Explanation of Significant Differences

**Fields Brook Superfund Site
Detrex Corporation Source Area (OU 5)**

January 2014

Detrex ESD - Figure 3

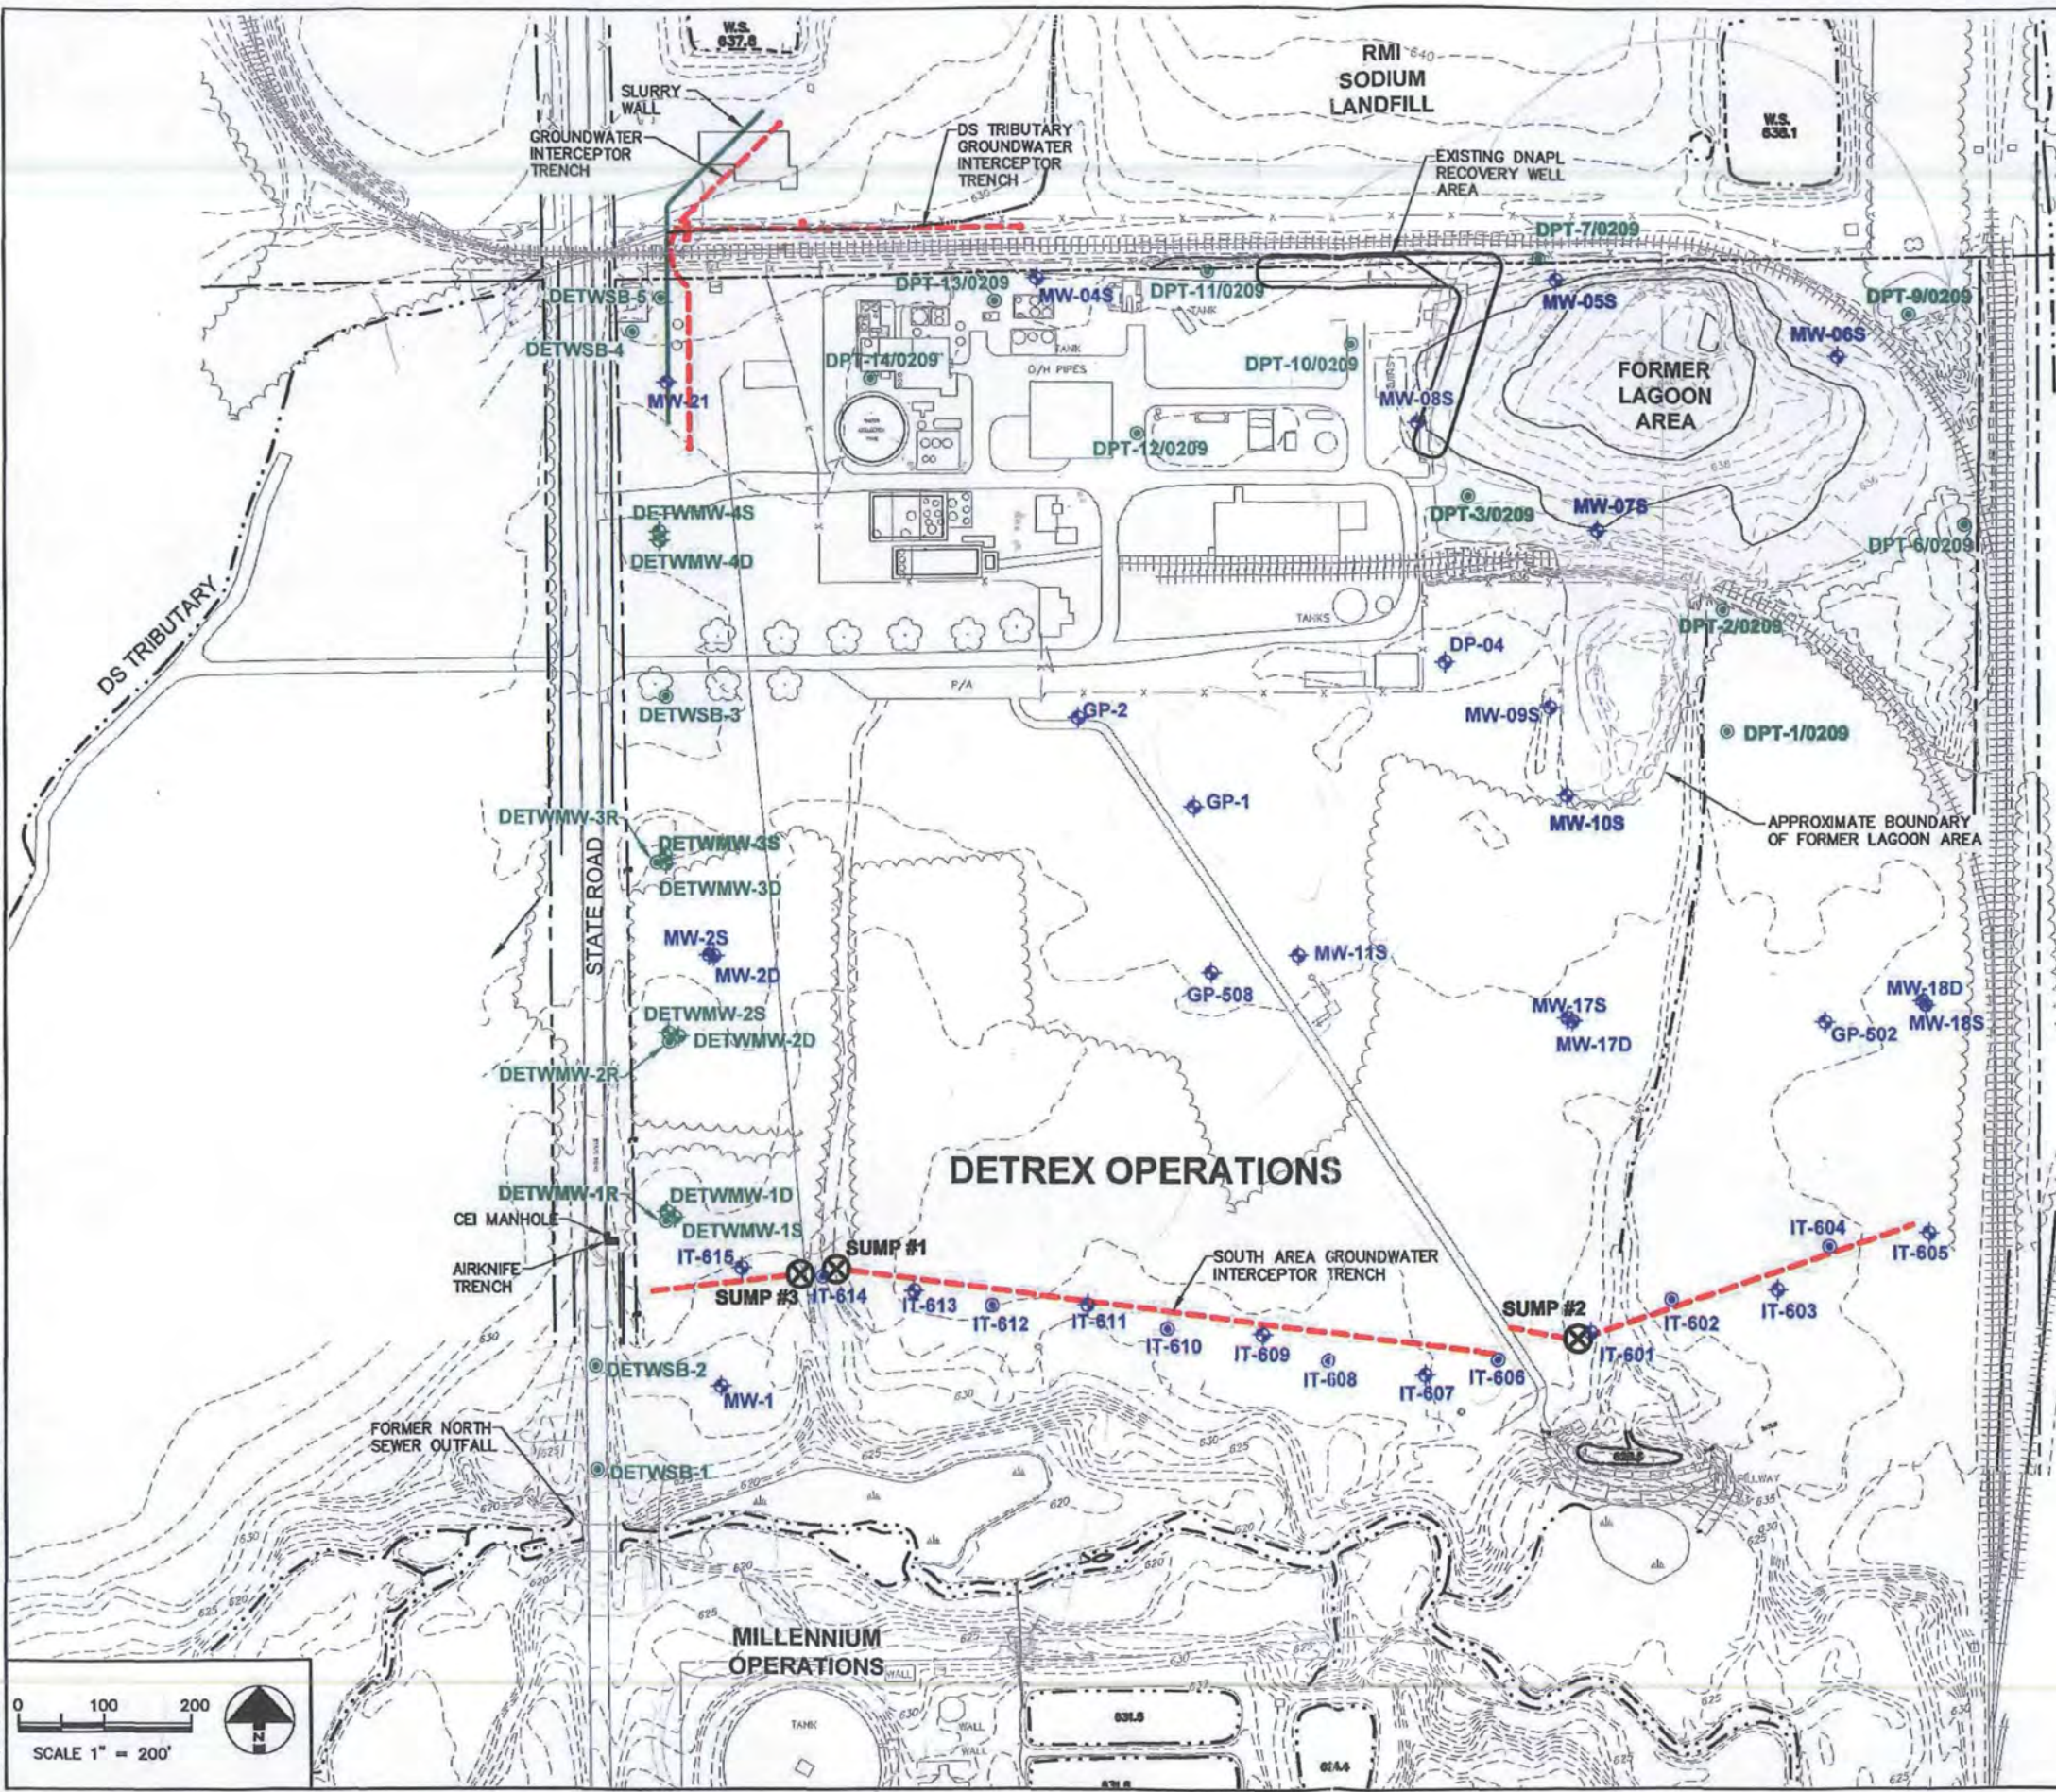
EPA and Detrex agreed that the DNAPL extraction system could be phased in to allow the system to be expanded based on field performance data and could be modified to address any problem experienced in the first phase of extraction wells. On October 4, 2001, EPA approved the remedial design for the phase 1 of the DNAPL extraction system. Detrex constructed the system in the summer of 2002. Upon start up in October 2002, Detrex encountered some severe operational difficulties (such as product crystallization and plugging of wells) and eventually had to move to a less automated approach to running the system since they found the extraction system requires close operator attention to maintain. Two additional wells were installed in 2007 and 2008 of modified design, and neither has worked as expected. All wells are located in the boomerang-shaped area labelled "Existing DNAPL Recovery Well Area" on Figure 3.

A partial 600 foot long slurry wall and groundwater collection trench was installed in 2001. This system was enhanced by construction of a groundwater containment system (i.e., GWIT) in the southern portion of the site in 2006 and 2007. (Fig 3). Based on groundwater data, these containment systems are effectively containing DNAPL and contaminated groundwater, and no additional slurry wall construction is necessary.

FIELDS BROOK
 ASHTABULA COUNTY, OHIO
 DETREX ESD
FIGURE 4
APPROXIMATE AREA OF
RECOVERABLE DNAPL

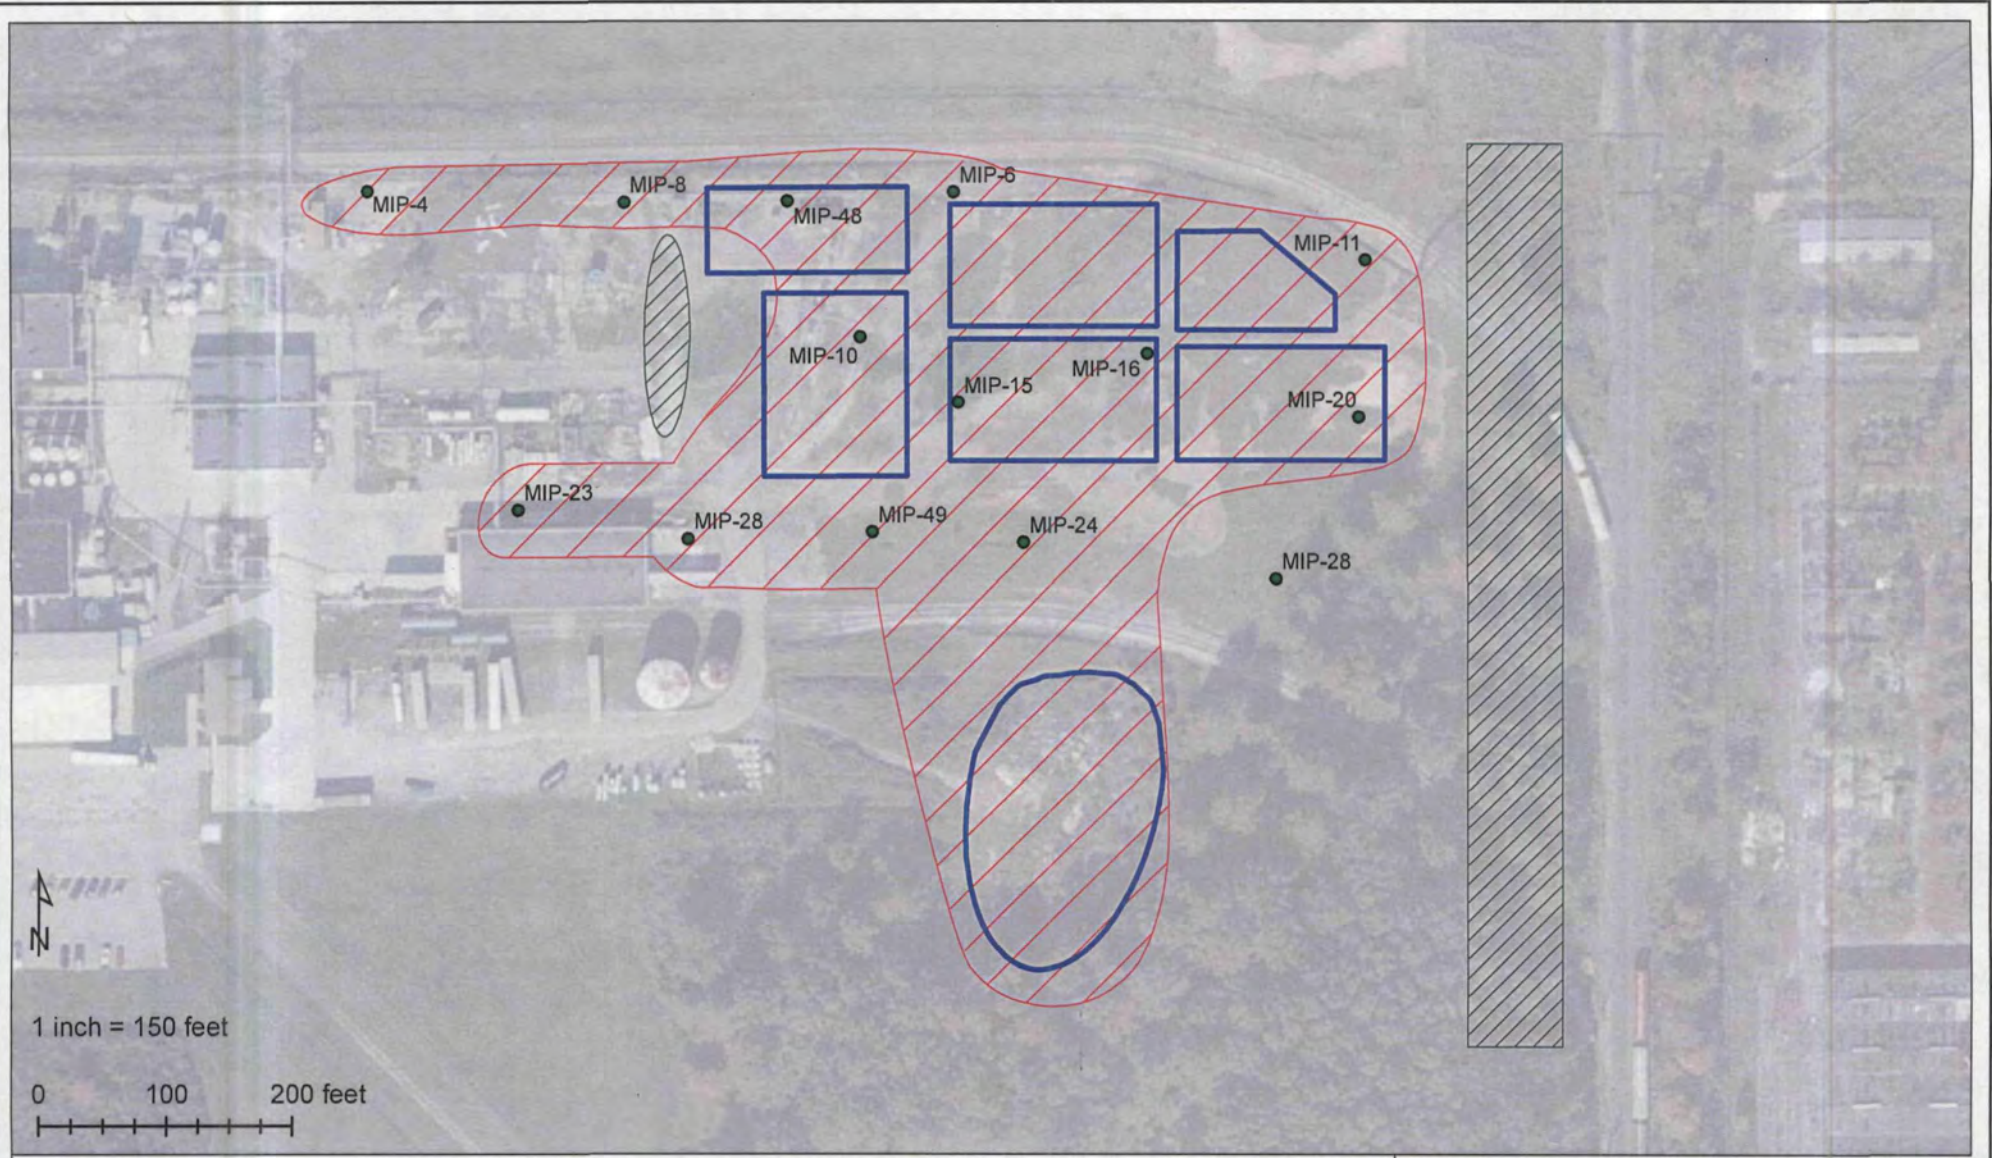
- The April 2012 “*Results of Membrane Interface Probe and Soil Boring Investigation*” report and the September 2013 “*Final Dense Non-Aqueous Phase Liquid (DNAPL) Recoverability Report*” will serve to identify DNAPL locations where the passive DNAPL recovery system locations will be proposed. These approximate locations are shown on Figure 4 of this ESD. Upon approval by EPA, additional information may be considered to propose additional recovery system areas or to delete previously identified areas.

- Passive recovery wells/subsurface recovery points around the perimeter of DNAPL areas will be located at intervals not to exceed (nominal) 15 feet.
- Passive recovery wells/subsurface recovery points located inside the DNAPL perimeter will be located at intervals not to exceed (nominal) 45 feet.
